**Agenda for Gig Harbor Design Review Board
Gig Harbor Civic Center
Thursday, June 11, 2026 at 5:30 P.M.**

**PLANNING DEPARTMENT
STAFF REPORT**

Gig Harbor High School Track and Field Renovation – Fence Height
Public Hearing Date: June 11, 2026

Re: Gig Harbor High School Field & Track Renovation
Permit Response Letter

FENCING & DIMENSIONING PLAN

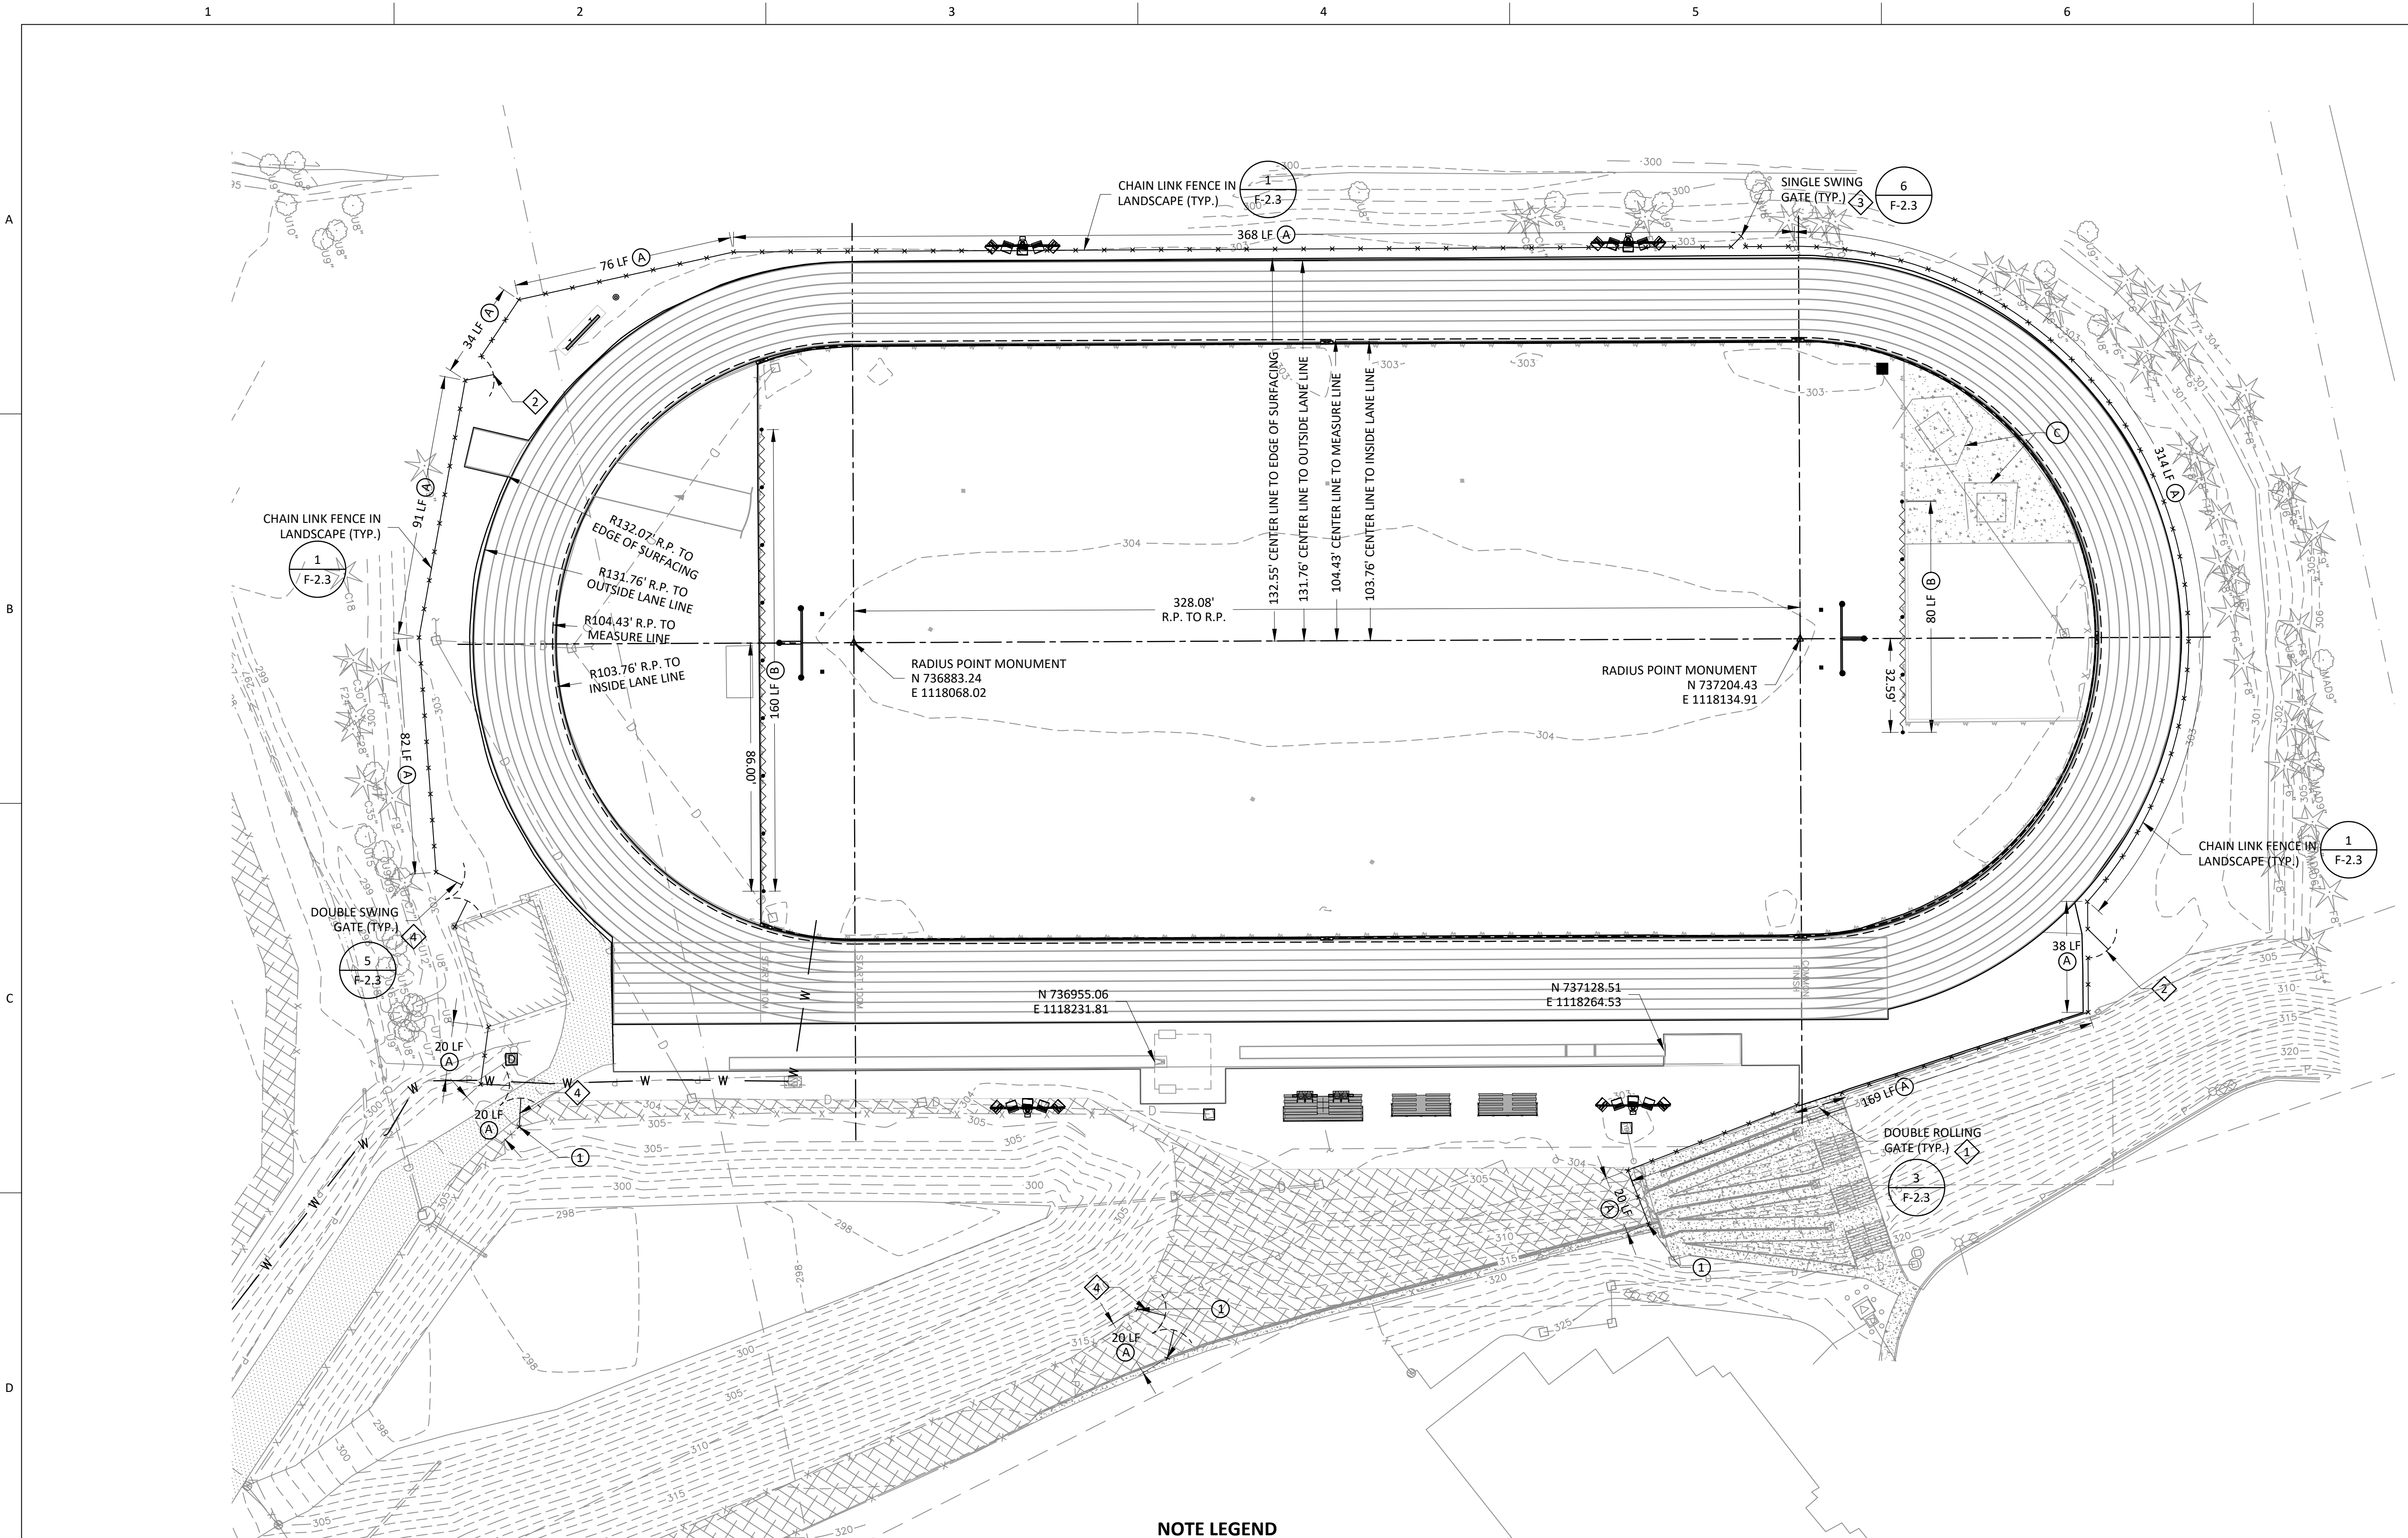
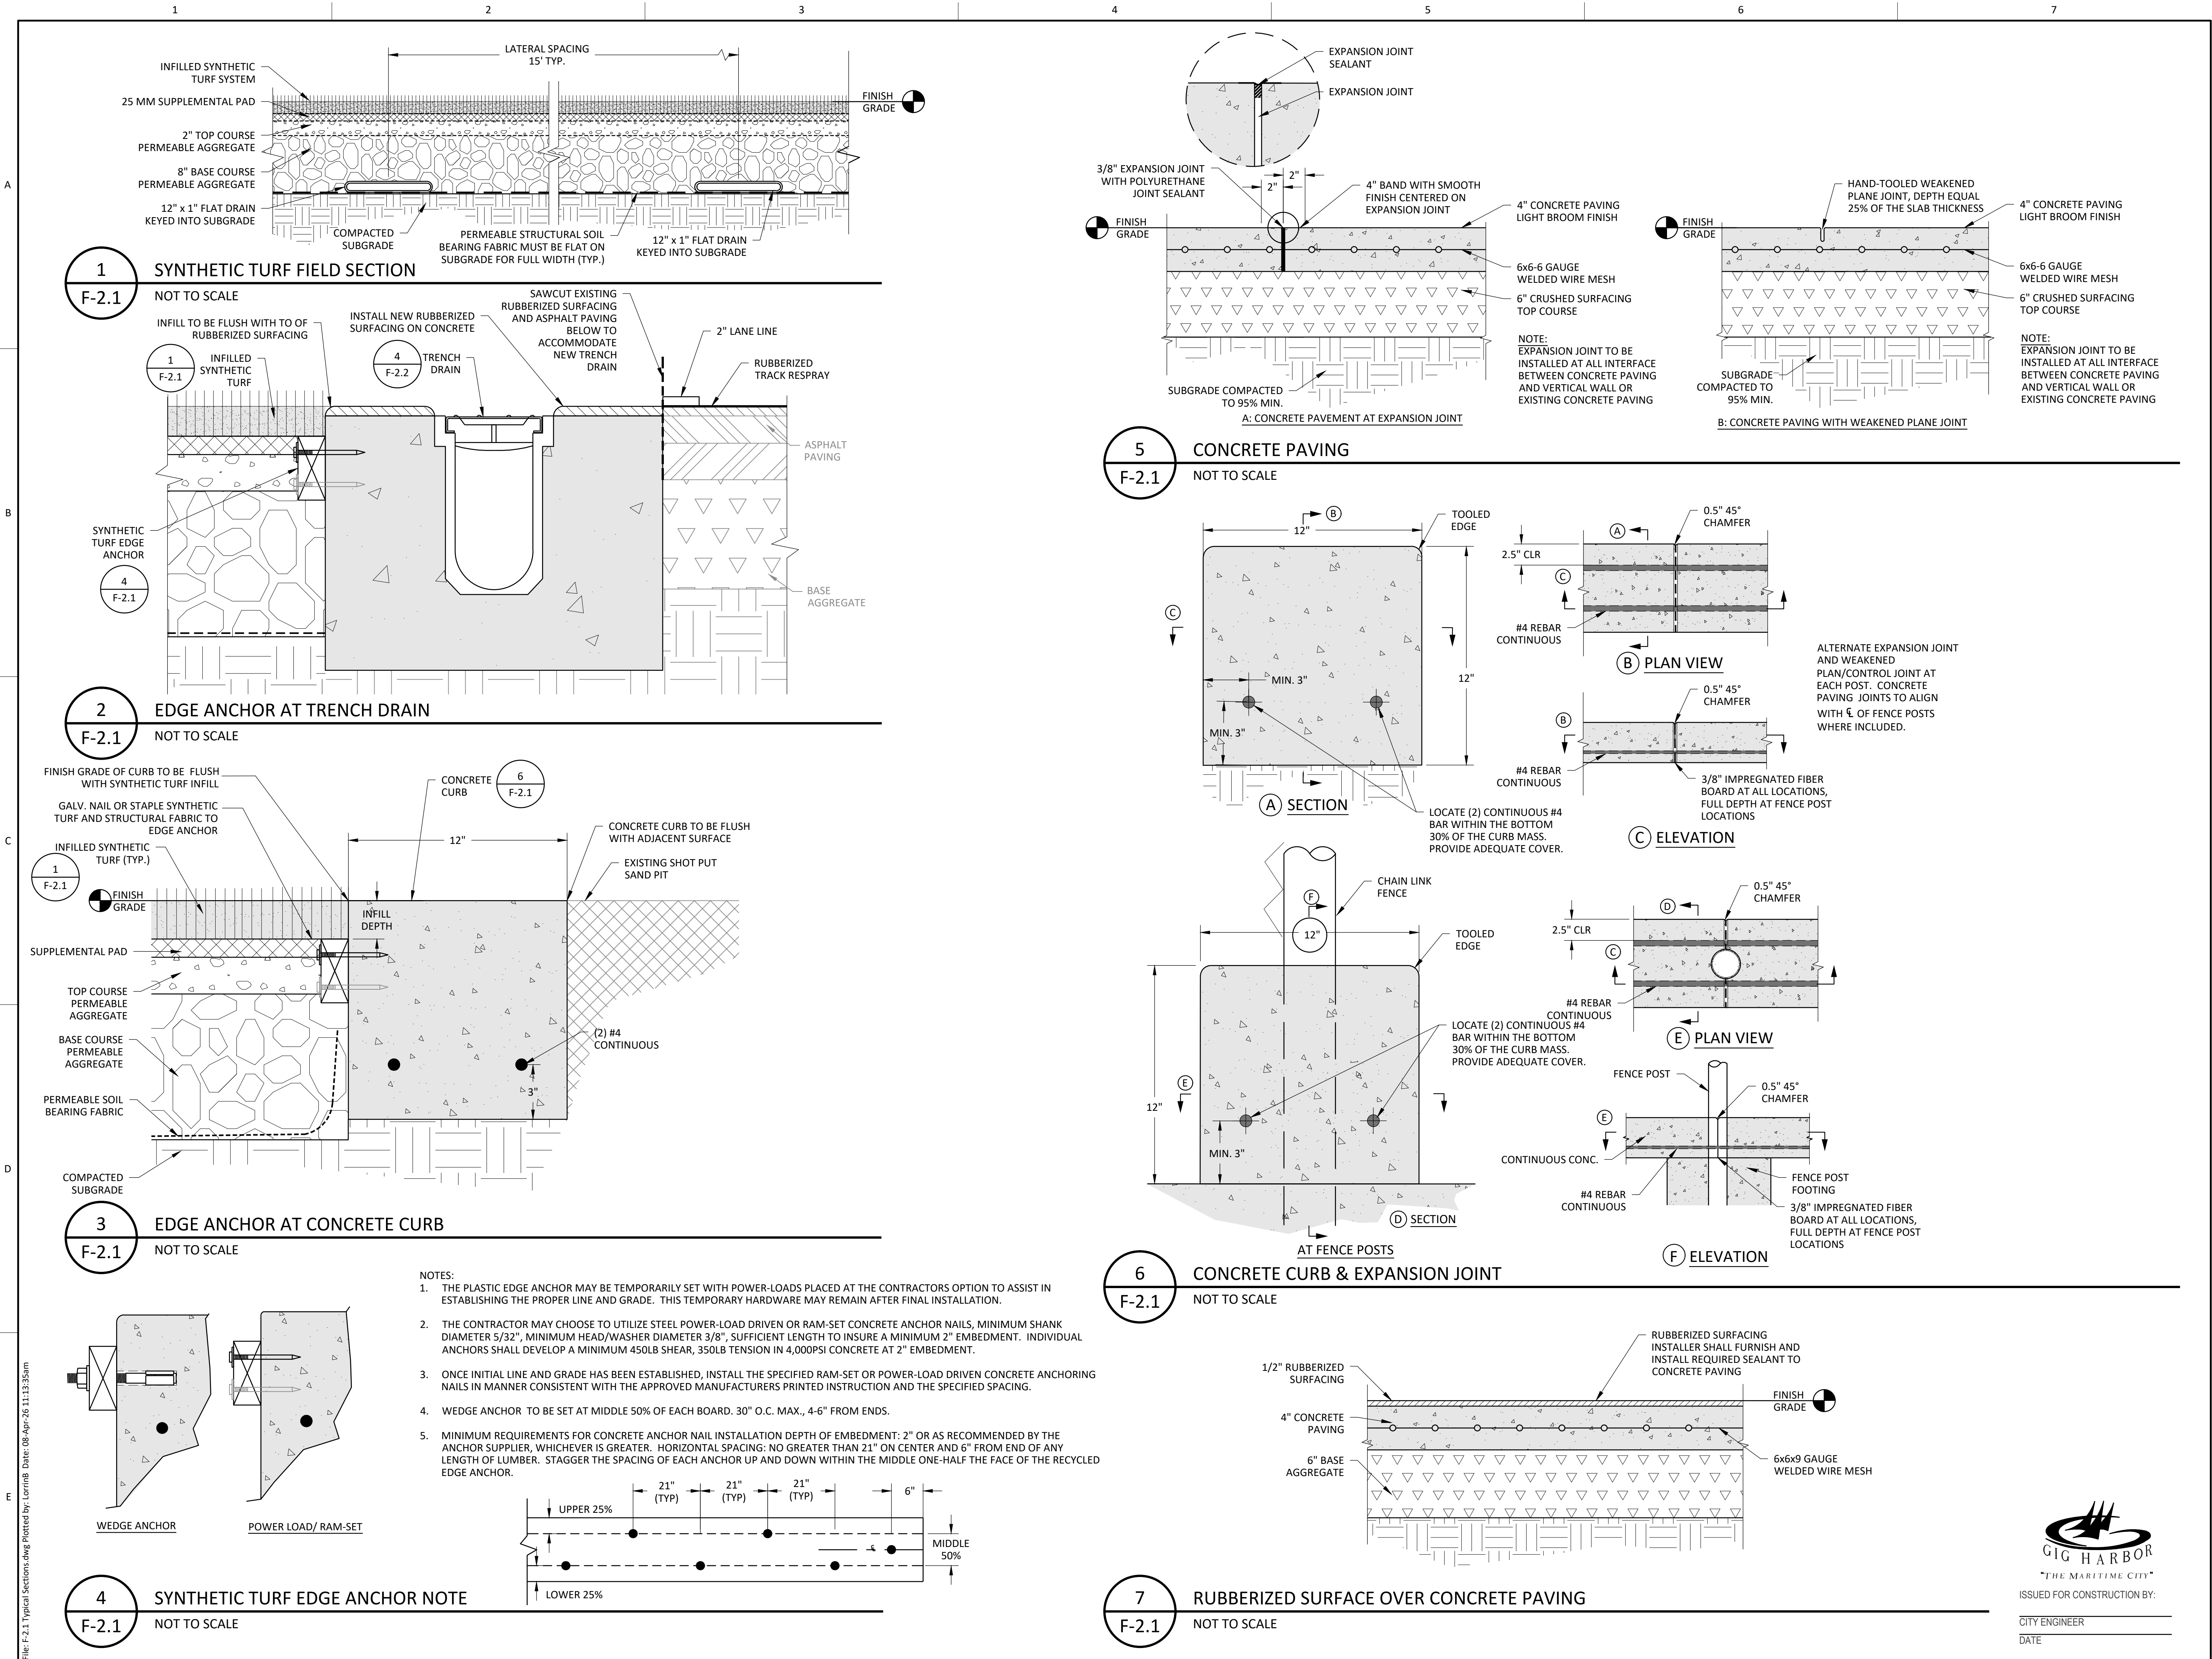
1. Per Gig Harbor Municipal Code section 17.99.340 (C) the maximum fence height is six feet. Please revise proposed eight foot fences throughout the project. Alternatively you may request review by the design review board (DRB) for the fence height that does not conform to the design manual per GHMC 17.98.055.

The school district would like to provide security for the site and control access for user groups, along with restricting access by unauthorized users. 8' fence successfully achieves both conditions on the existing fields, and would enhance the proposed field and track area.
